From: [Charlie Hampton](#)
To: [Wiegiers, Janice K \(DEC\)](#)
Cc: [Ryan Kingsbery](#)
Subject: RE: GTE / BJ Fuels
Date: Wednesday, March 13, 2024 1:50:14 PM
Attachments: [image001.png](#)
[image004.png](#)
[image005.png](#)
[image006.png](#)
[GTE-BJ's Fuel Closure Report 3-13-24.pdf](#)

Here are my final comments for the cleanup report. Please revise the report to clarify these items.

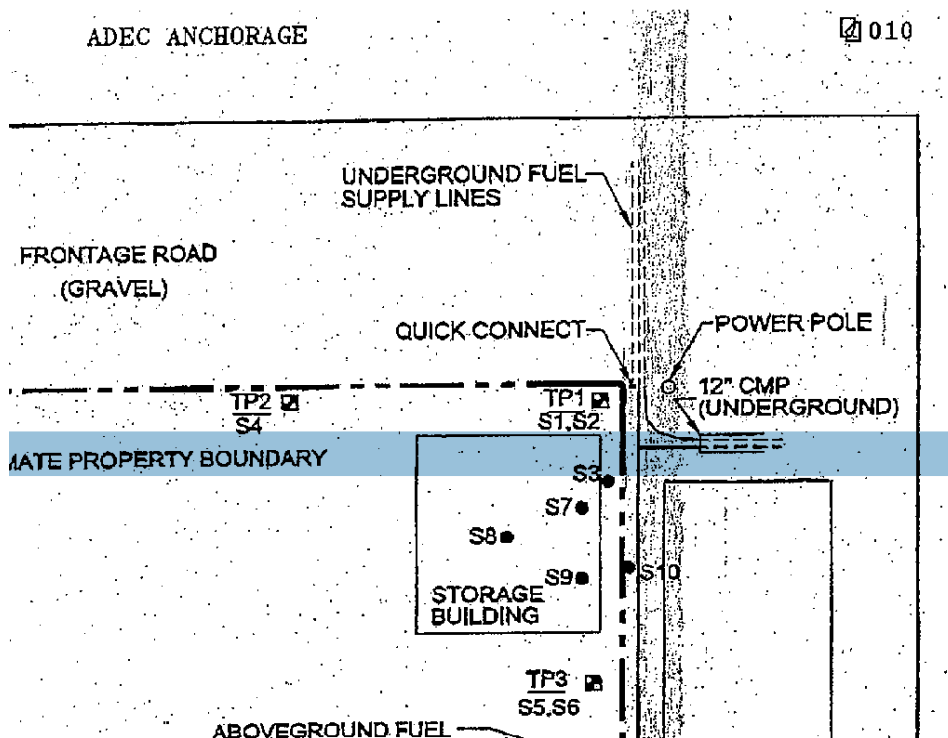
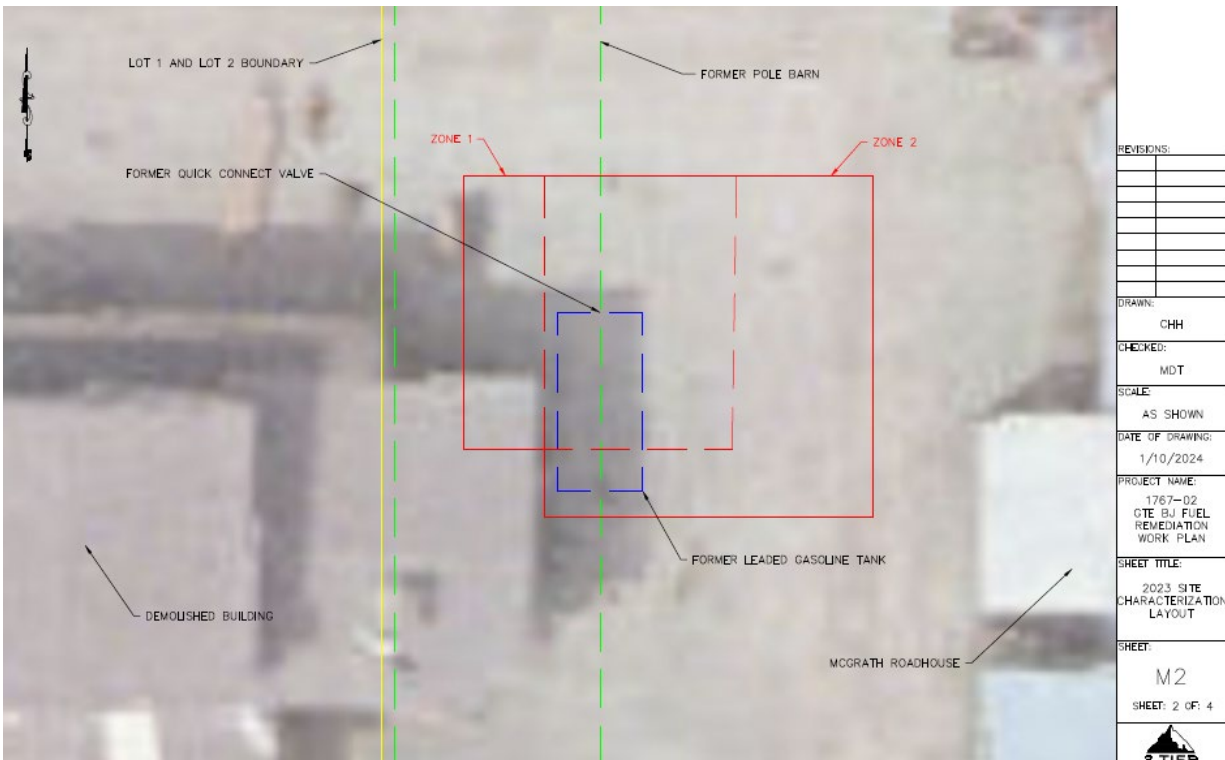
I'm still finding some inconsistency with the available information that makes me question the sampling location. According to the text, maps, and photos in the 1999 and 2003 reports, Area 1 was in the area of that former power pole and the T or bend in the fuel supply lines from the runway where AGI observed something they described as a quick connect. Based on that information, I would expect Area 1, where contamination was found which was not excavated, to be north of and on the west side of the former pole barn location. Based on Figure M2 in your report, Mr. Magnuson appears to have directed the work to a more central location in Lot 2, underneath and toward the east side of the pole barn. I understand that lot lines are questionable in the older reports, but I would expect some accuracy with respect to the landmarks (pole barn location).

Does Figure M2 seem accurate with respect to the location of the pole barn and the quick connect observed by AGI? I'm including part of the figure from the 1999 AGI investigation, and Figure M2 from your recent report below.

Regarding the accuracy of the pole barn location in Figure M2, I do not believe the figure is accurate. As a reminder, I created this figure based on a verbal description of the pole barn in the field, recalled from a 25-year-old memory.

The east/west location of the pole barn is relatively accurate, but the northern extent of the pole barn is certainly not accurate. Based on the figure in the AGI report, we know that the pole barn did not extend all the way to the quick connect, but we do not know how far it extended. We excavated

approximately 10-20 feet from the edge of pavement (photo attached). The AGI report shows that the quick connect is directly on the property line. However, AGI did not survey the property to verify this location, and we do not know on what basis they established a property line. It appears the property line was based on the location of a power pole, which is no longer in place for me to use to reference the location in the AGI figure. We do not know where the property line is located relative to the existing edge of pavement, thus it is difficult to say with certainty where my excavation lay relative to the location identified by AGI as a quick connect. Based on this uncertainty and the location of my excavation within approximately 20 feet from the edge of pavement, it is possible that our "Zone 1" included or abutted the vicinity of the quick connect.
